Model Difference Letter

Changyou Technology (Zhejiang) Co., Ltd., is applying for FCC ID: 2BEKX-SYW for the model: TO-Q-SY2-JWT. The PCB layout is as follows:

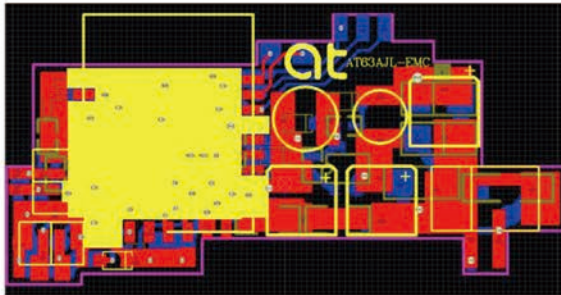
There is another model: TO-Q-SY1-JWT.

Differences: TO-Q-SY1-JWT is based on TO-Q-SY2-JWT but with the removal of the temperature sensing resistor (100K ohm NTC).

All other electrical principles, performance, functions, and key components used internally are the same. These differences will not affect the qualified assessment of electromagnetic compatibility and safety regulation tests.
